**From:** Coltrain, Katrina  
**Sent:** Monday, July 06, 2015 11:22 AM  
**To:** Kady, Thomas; Powell, Greg; Prince, George  
**Cc:** 'Downham, Todd'; Werkema, Dale  
**Subject:** RE: Wilcox Refinery Geophysical Approach and Budgetary estimate  
**Attachments:** ERT Geophysics proposal draft 7-6-15.pdf; Wilcox Property ownership.pdf; 1941.pdf

Team, I have reviewed the geophysical approach and have the following questions and comments. If you have any questions regarding my review, please give me a call or send an email.

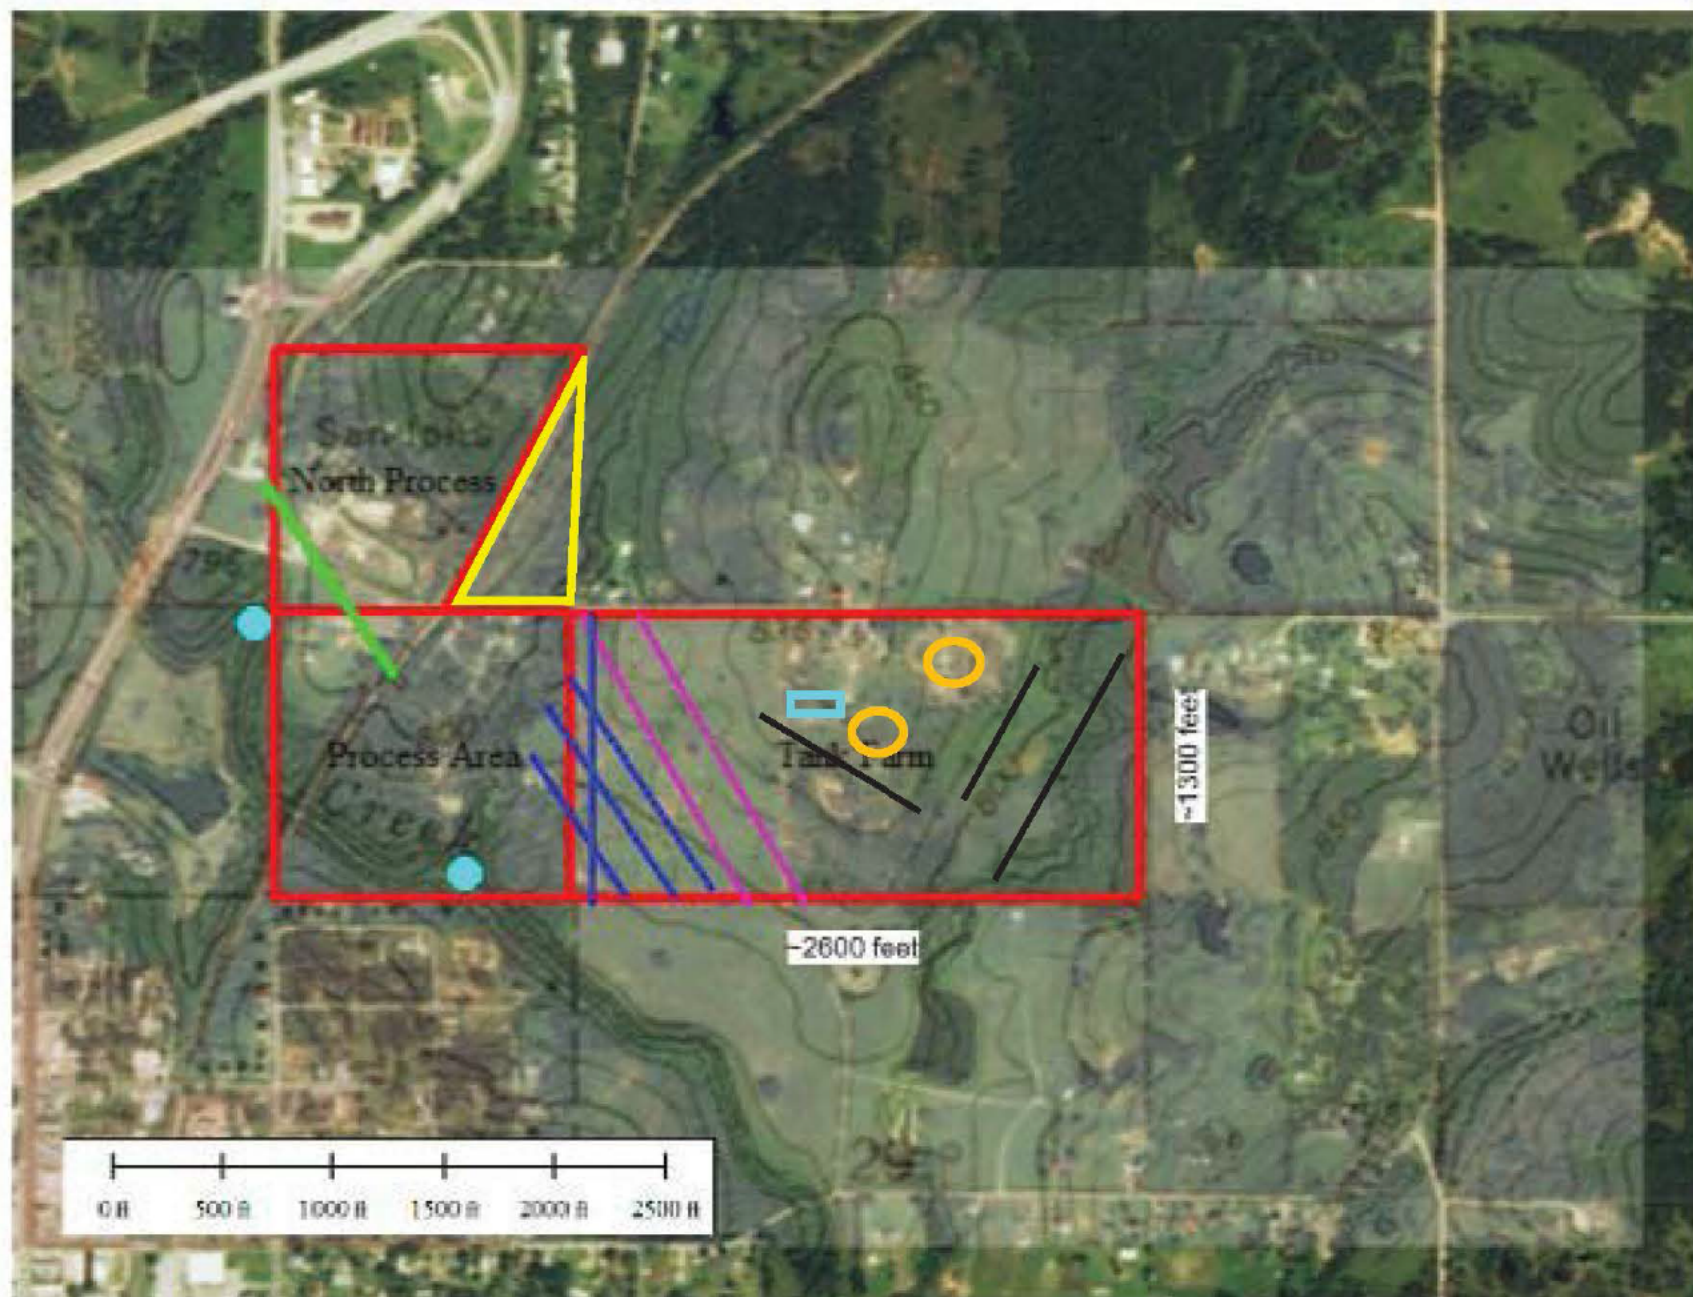
Areas of interest are indicated in orange. We are interested in these areas and preferential pathways associated with these tank locations.

The property (Property 4) next to the field has a fenced pit. We are interested in this area and preferential pathways associated with the pit. Area indicated in light blue. Refer to the 1941 pdf attached to this email.

The text indicates that the initial effort will focus on the tracks identified in the figure and marked as blue and pink. Once completed, then additional tracks across the properties will be investigated. I have included some

suggested locations in black that can be used to address the issues identified above. Refer to the ERT Geophysics proposal draft 7-6-15 pdf attached to this email.

1. Can the number of tracks cited for the southwest corner of the field (Property 7) be reduced so that additional tracks across other parts of the site can be done?
2. When you have a better idea of the dates, we will need to coordinate with the property owners/tribes to let them know what we are planning and when.

Suggested lines to concentrate on to determine pathway from source area to seep.

— May be possible in the process area to investigate the seep

Figure 3 – Current Owner Map

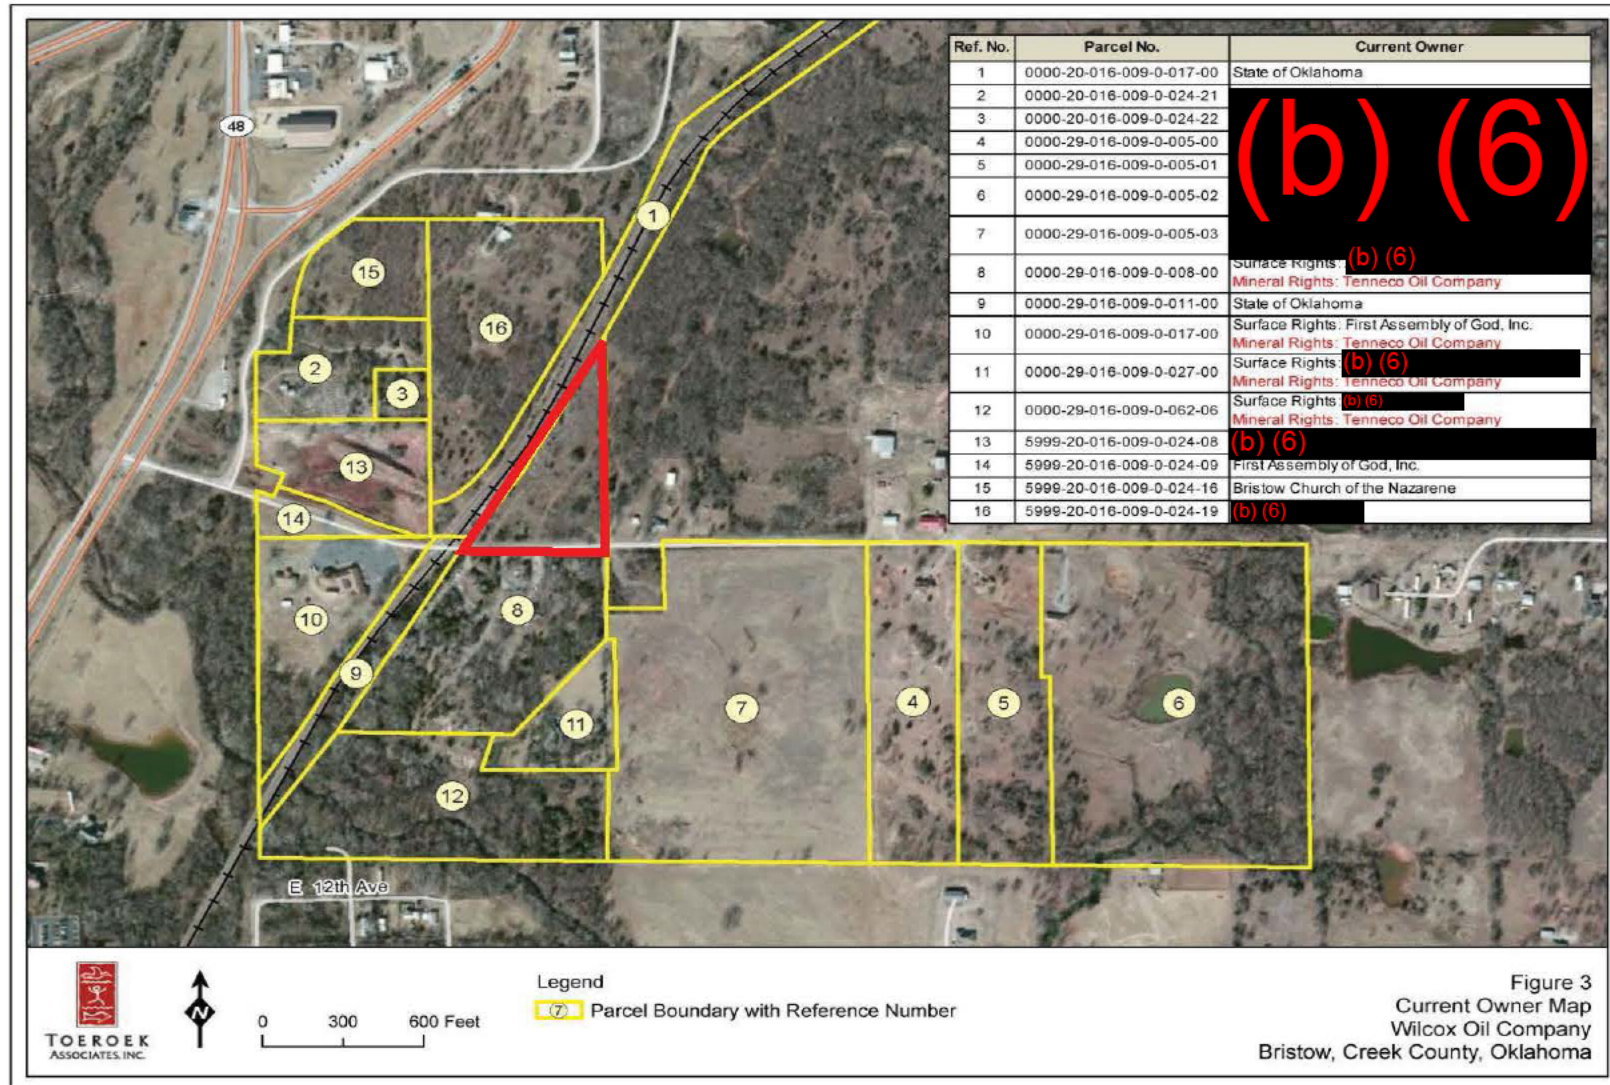
I have no comments on the use of these surveys. I agree that they should be used in the process and north process areas. We do not have full access to the north process area. See attached pdf, reference property 2 and 13. We are working to identify the owner for property 2, and working to get a signed access agreement with property 13. We may need to alter the tracks just a bit if we are not able to get access by field time. Specifically, the northern end of the green track line may need to be adjusted..

If needed, we have access to a triangle wedge just north of the Process area. Indicated with yellow.

The MASW is planned for the Tank Farm Area. This area includes 4 properties, only one of which the owner has agreed to mow. The other three properties have homes and are currently occupied. Refer to the Wilcox Property ownership pdf attached to this email.
